OXFORDSHIRE COUNTY COUNCIL'S RESPONSE TO CONSULTATION ON THE FOLLOWING DEVELOPMENT PROPOSAL

Application no: 23/02715/REM

Proposal: Reserved matters approval for 23/01080/OUT - Details of access, appearance, landscaping, layout and scale relating to the proposed development of a Class E(g)(i) (formerly B1(a)) office/commercial building and associated development, plus associated car parking

Location: Land North Of Bicester Avenue Garden Centre, Oxford Road, Bicester

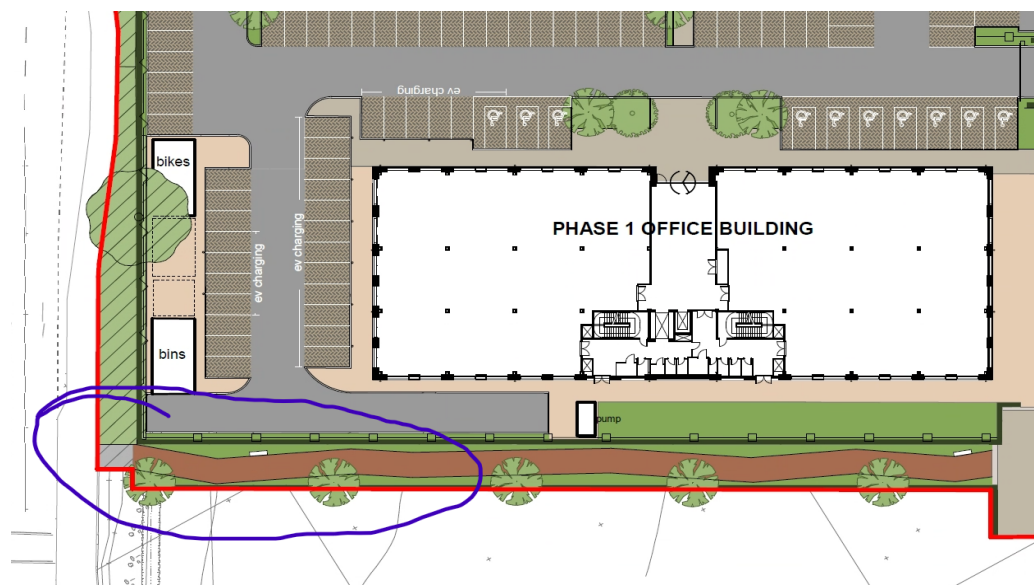
The application proposes up to 226 car parking spaces of which 10 are Accessible spaces and 22 provided with Electric Charging ports.

First, the overall car parking provision is in excess of the required for the type and scale of development. The County's parking standard for new developments for the scale of this development prescribe a maximum of 160 spaces. See link below. **(Reason to object)** [Parking standards for new developments \(oxfordshire.gov.uk\)](https://www.oxfordshire.gov.uk/parking-standards-for-new-developments)

I also note from the Design and Access Statement that only 22 out of these spaces are kitted with a charging port. This is below the requirement and contrary to Policy EV1 8 of the County's Electric Vehicle Infrastructure Strategy which categorically requires at least 25% of the spaces to have charging points installed for non-residential developments. **(Reason to object)** [Oxfordshire Electric Vehicle Infrastructure Strategy](#)

The proposed level of cycle parking is further noted to significantly fall short of the required. Again, set in the Parking Standards, the type and scale of this development requires up to 66 cycle parking spaces for staff and up to 26 for visitors. Visitor parking should ideally be covered and placed within proximity of the building entrances, while staff cycle parking must be in secure and sheltered facilities. See Table 5: Non-Residential Parking Guidance for Oxfordshire in OCC's Parking Standards. **(Reason to object)**

The Site Plan appears to indicate provision of a footpath off the A41 into Bicester Arc, although this is not directly linking into this phase of development. Can this be confirmed. Assuming that this is the case, the surfacing needs to be clarified as the illustration of the footpath without a legend is misleading.

It is OCC's preference that a footpath/cycle path off the A41 that directly links into this development is provided across the car park.
